ALEXANDRIA PARK

COMMUNITY SCHOOL

RESPONSE TO

3 OCTOBER 2018
SA6700
REVISED FINAL
PREPARED FOR NSW DEPARTMENT OF EDUCATION

Figure 1 – Adjustment to location of gymnasium block to address overshadowing on 58-60 Belmont St

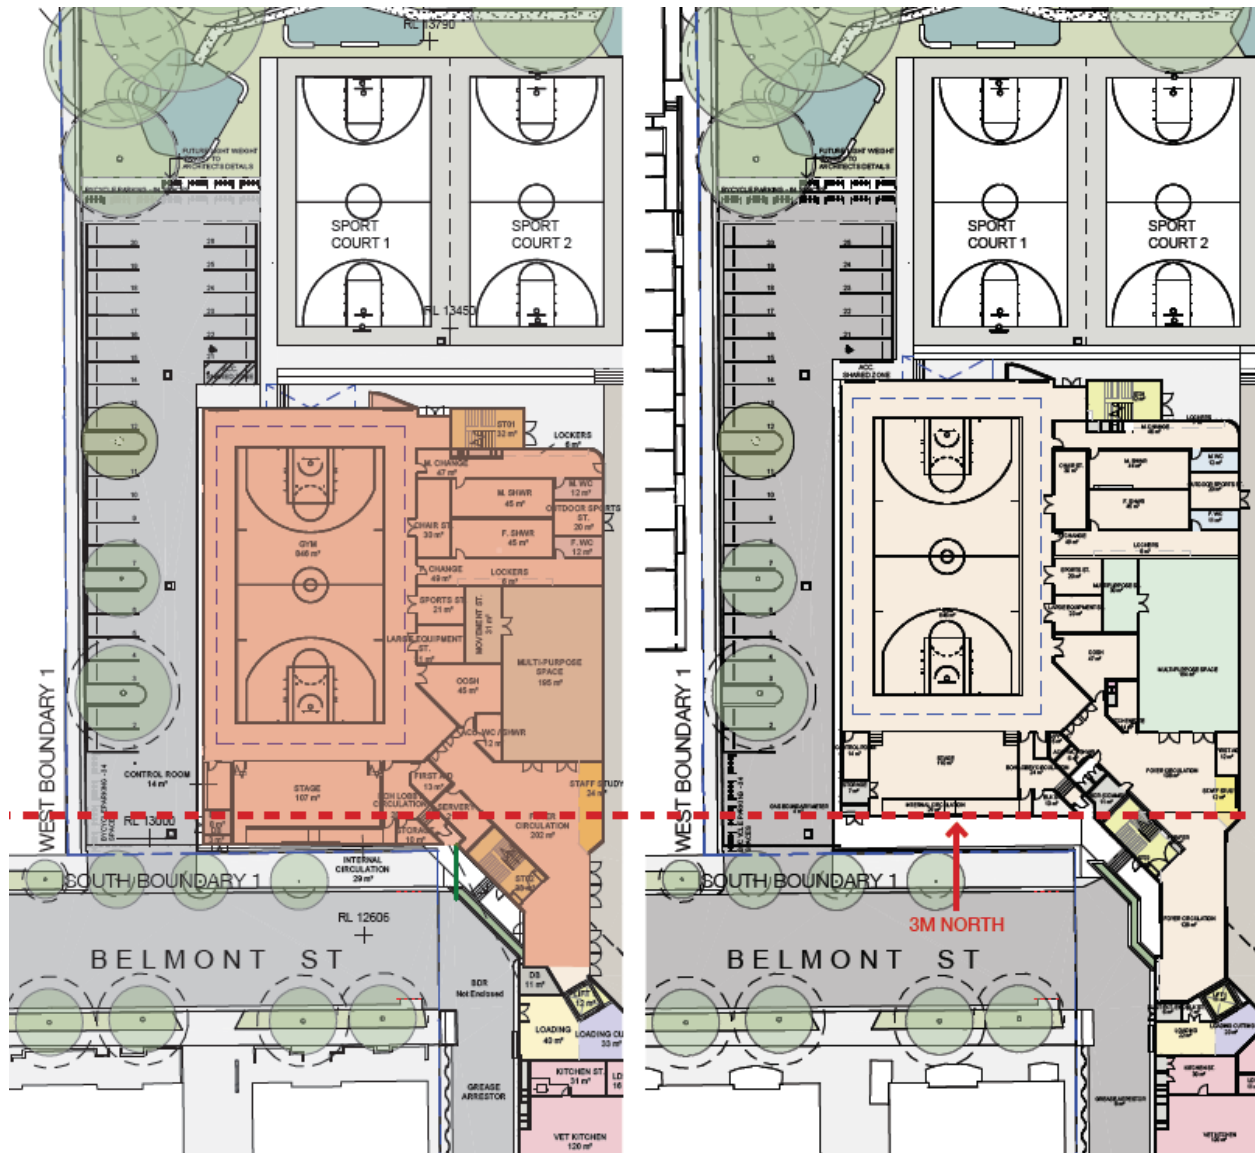
In response to agency and public submissions the project team have revised the building mass in the following ways:

- Shifting of the gymnasium block (Block A) and associated learning spaces 3m to the north;
- Portion of Block A has been reduced to a 1 storey component. This amendment is located along the South edge of the gymnasium block facing Belmont Street and at a depth of 1.9m
- Shifting of primary school blocks C2, D1 and D2 to create a wider gap between blocks C2 and D1.

Figure 3 – 58-60 Belmont Street – 3D Shadow Analysis (Winter Solstice at 2pm)

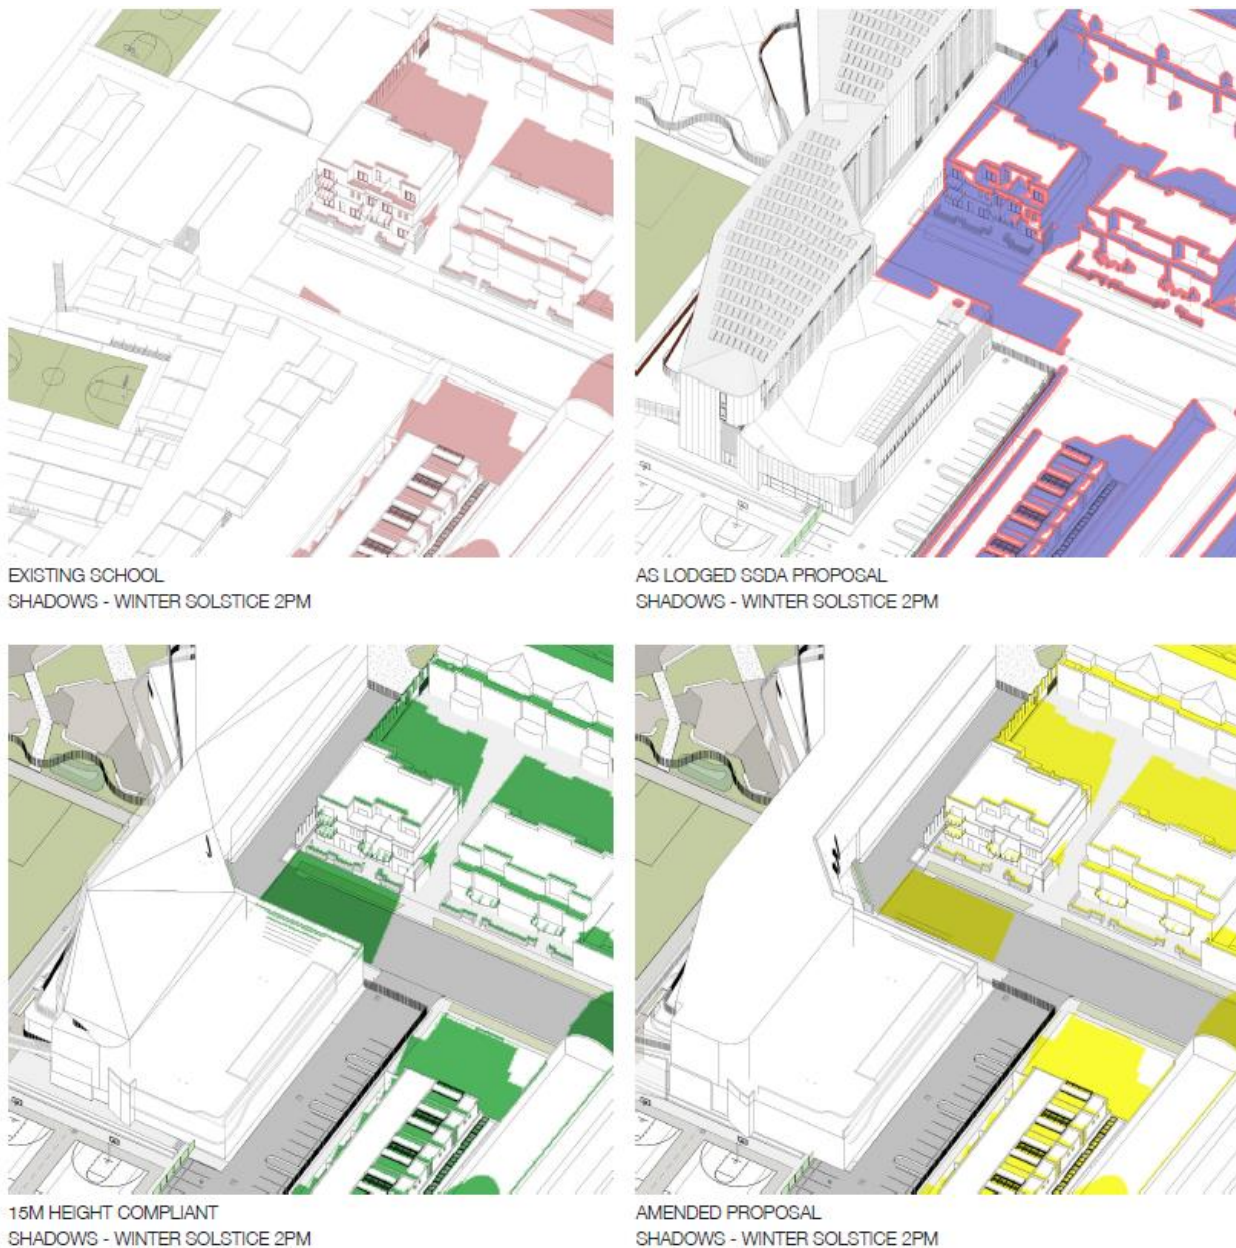
TKD have amended the proposal to improve solar access to 58-60 Belmont Street when compared to the original SSDA. Figure 3 illustrates by shifting the proposed hall 3m north, the Belmont Street building receives much more sun at 2pm in mid-winter. An hour-by-hour analysis of sun access to the northern facing apartments is detailed in Table 1. The table shows that Units 1, 2, 3, 17 and 18 will receive an additional 1-2 hours of sun with the amended proposal. Overall, all apartments will receive at least 2 hours of solar access in mid-winter. This is consistent with the Apartment Design Guide (ADG) and Sydney Development Control Plan 2012 (SDCP). The amended proposal is therefore an improvement and addresses community and agency submissions. This is discussed in more detail in Section 4 of this RtS.

Figure 6 – 92-94 Buckland Street (First Terrace Unit) – Existing

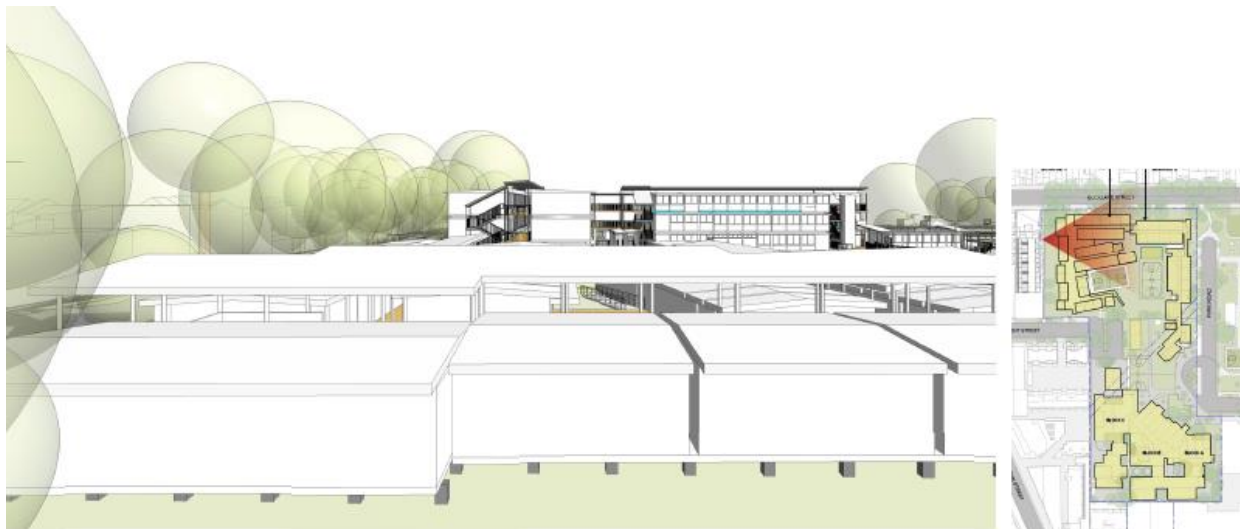
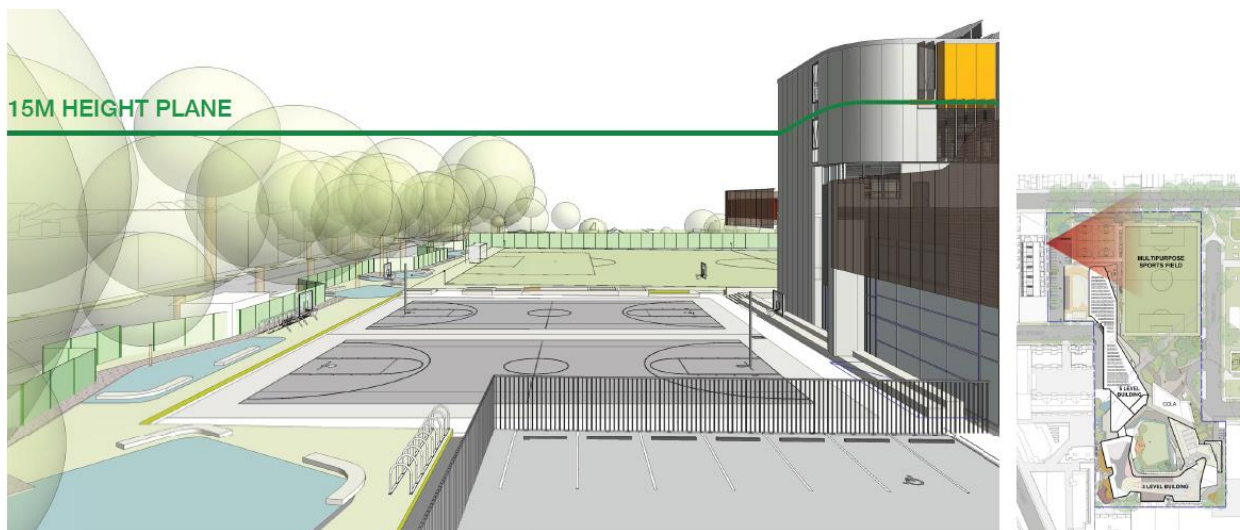
The first (northernmost) terrace unit at 92-94 Buckland Street currently looks to the east over the existing temporary school. Prior to the pop-up school, the unit would have had views of the park. The pop-up school has been lawfully established under separate approval.

When the pop-up school is demolished, the view will be of sports courts and Alexandria Park. A small portion of the view toward the park is lost. The proposal will improve the view from this apartment when compared to the existing situation. The view loss is assessed as negligible.

Figure 9 – 92-94 Buckland Street (Last Terrace Unit) – Proposed

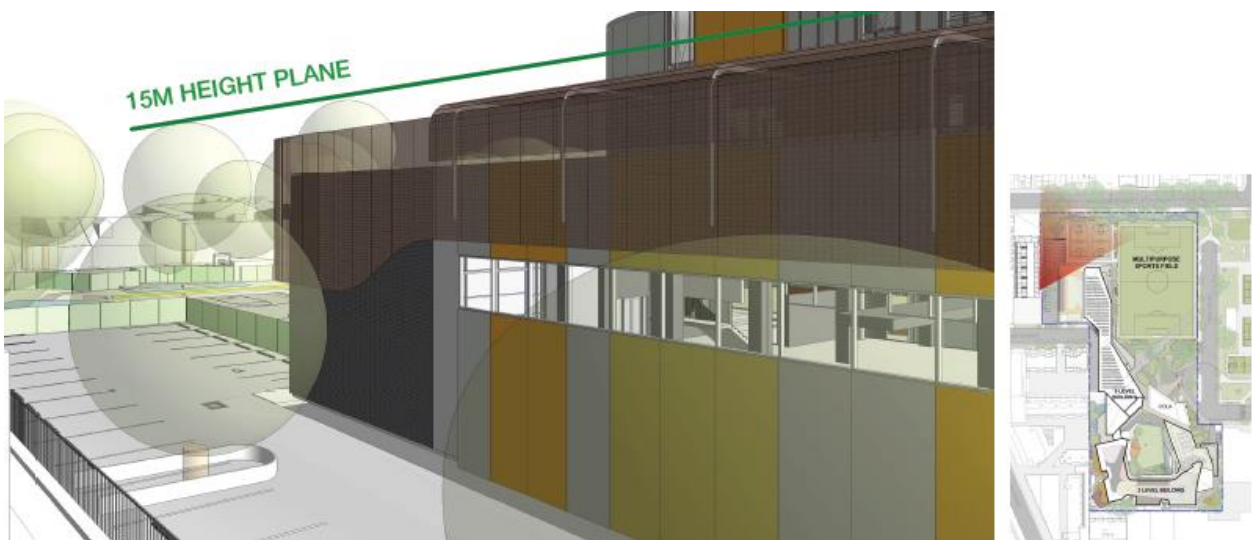
The last (southernmost) terrace unit at 92-94 Buckland Street currently looks to the east over the existing temporary school and has obscured views of trees on Buckland Street. This is an oblique view across side boundaries. The proposal will impact 75% of this view. The impact is reasonable because:

- The view is not iconic.
- The proposal complies with the FSR development standard.
- The proposal complies with the height development standard on this part of the site. A compliant development in this location would have greater impact.
- Existing trees on the boundary are retained.
- New trees will be planted on the school site, improving the outlook.

The view loss is assessed as minor.

Figure 10 – 58-60 Belmont Street - Existing

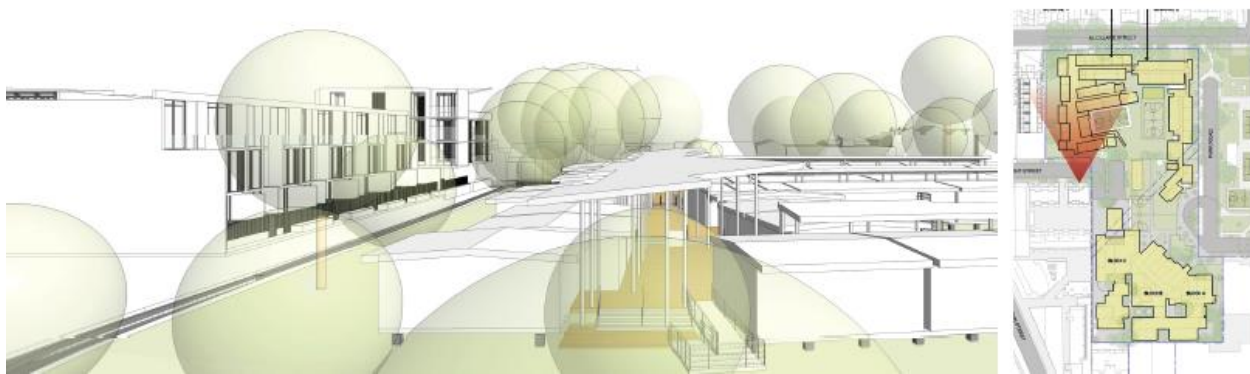
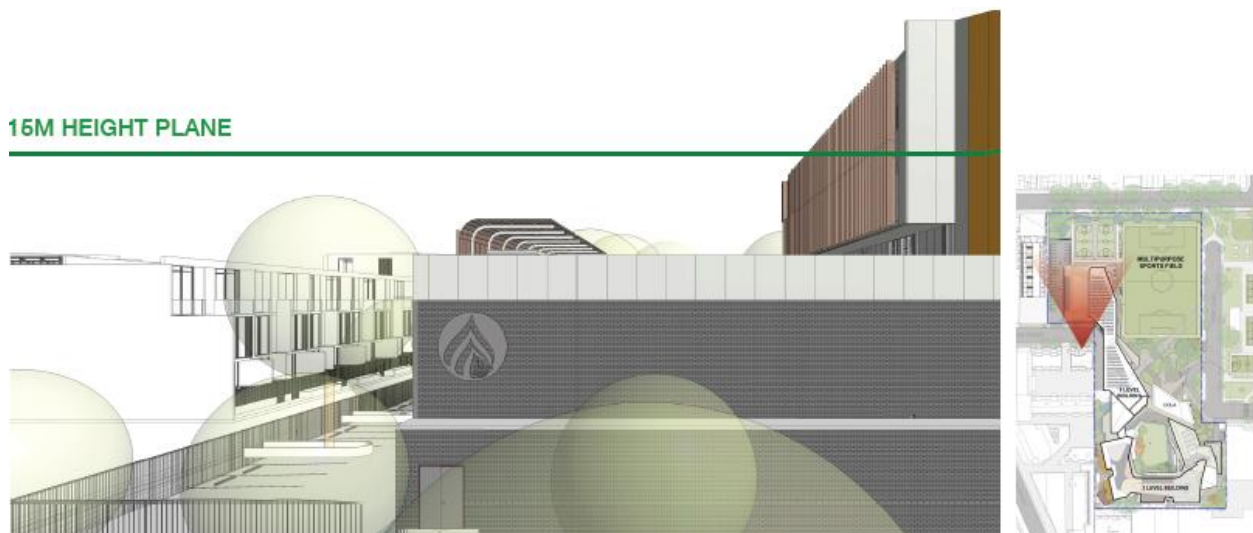
The easternmost unit at 58-60 Buckland Street looks north over the existing temporary school and has obscured views of tree canopy on Buckland Street. The proposal will impact 70% of this view. The impact is reasonable because:

- The view is not iconic.
- The proposal complies with the FSR development standard.
- The proposal generally complies with the height development standard on this part of the site. A compliant development in this location would have greater impact. The non-compliant portion of the building will impact sky views only.
- Existing trees on the boundary are retained.
- New trees will be planted on the school site, improving the outlook.

The view loss is assessed as minor.

Figure 12 – 15-17 Fountain Street (Top Floor Apartment) – Existing

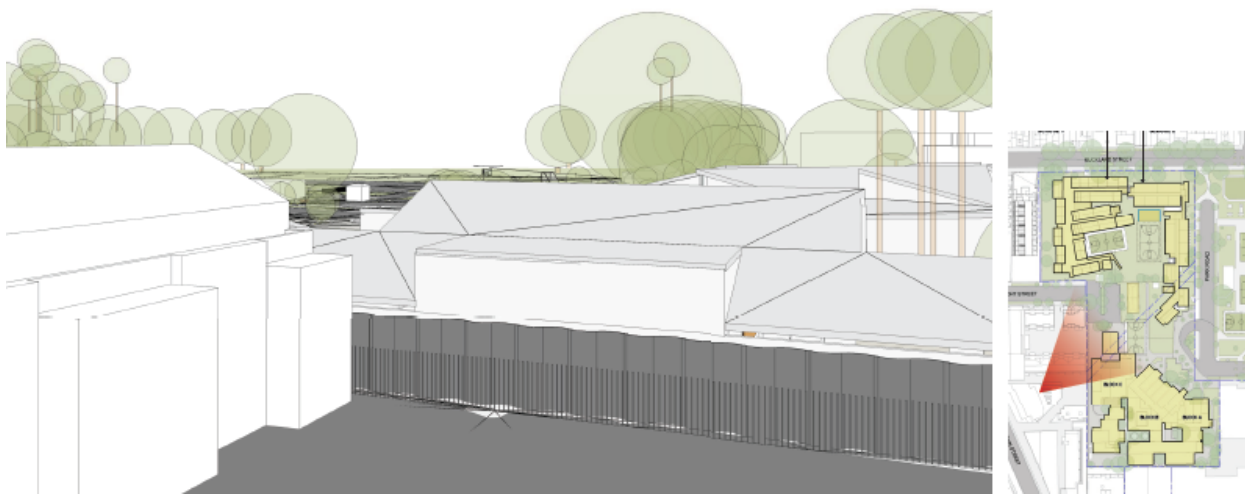
The top floor apartment at 15-17 Fountain Street (taken at 13m above ground level) looks over the existing school and has partial views of tree canopy and Alexandria Park. The view is from the rear of the property across side boundaries. The proposal will obscure this view. The impact is reasonable because:

- The view is not iconic.
- The proposal complies with the FSR development standard.
- The proposed height non-compliance in this location is minor. A compliant height would not result in a better outcome. The greater height non-compliance is further into the site and impacts distant tree canopy views.
- A reduction in height would not nearly achieve the accommodation requirements to meet the demand for schools in the City of Sydney.

The view impact is assessed as moderate. However, the impact is reasonable and needs to be weighed against the significant social benefit.

Figure 14 – 145 McEvoy Street (Top Floor Apartment) – Existing

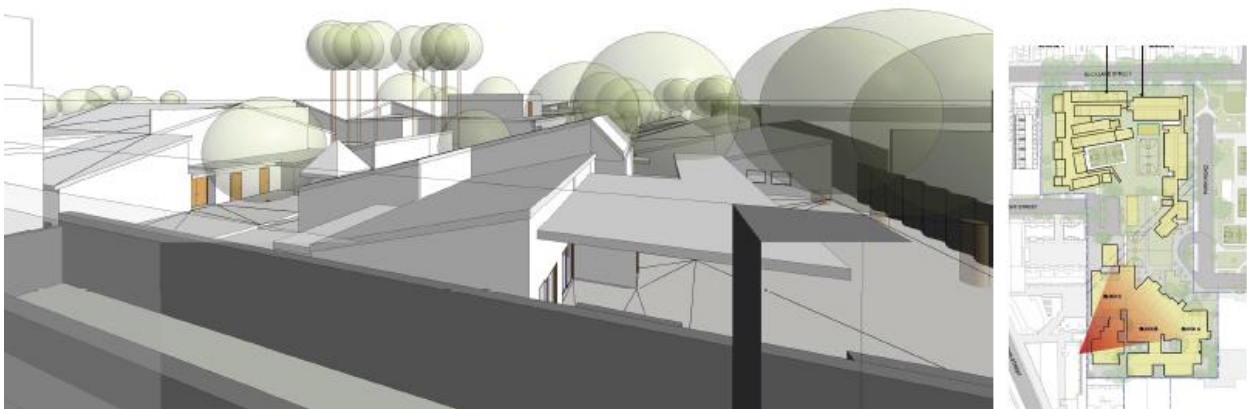
The top floor of 145 McEvoy Street (taken at 7.5m above street podium level) looks over the temporary school to tree canopy. The view to Alexandria Park is largely obscured. This is an oblique view across side boundaries. The proposal will obscure this view. The impact is reasonable because:

- The view is not iconic.
- The proposal complies with the FSR development standard.
- The proposed height non-compliance in this location is minor. A compliant height would not result in a better outcome.
- A reduction in height would not nearly achieve the accommodation requirements to meet the demand for schools in the City of Sydney.

The view impact is assessed as minor.

Figure 16 – 141-143 McEvoy Street (Top Floor Apartment) – Existing

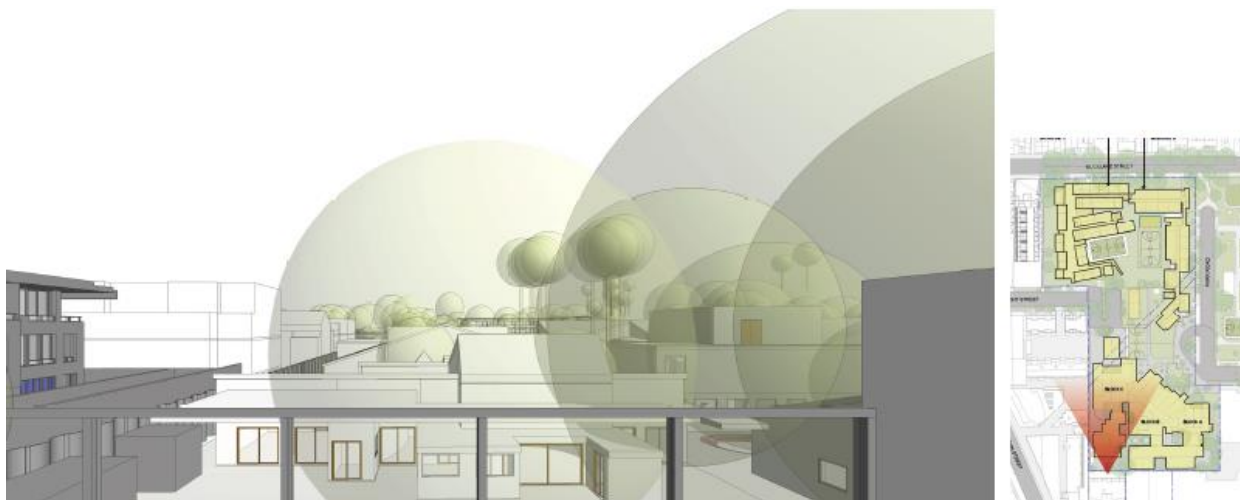
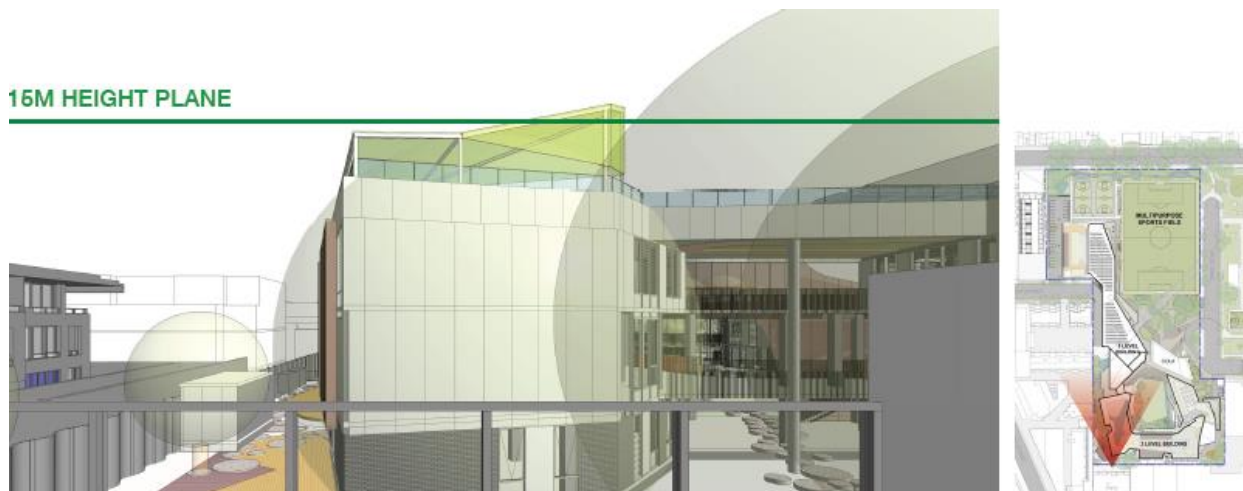
The top floor of 141-143 McEvoy Street (taken at 10.5m above ground level) has foreground views of existing trees. These trees are to be retained and obscure views over the temporary school to trees on Buckland Street. The view is from the rear of the property. The view is not iconic. The proposal will impact the obscured/partial view.

The proposal generally complies with the height development standard in this location. A compliant height would have a better outcome. The view loss is assessed as minor and is reasonable in the circumstances.
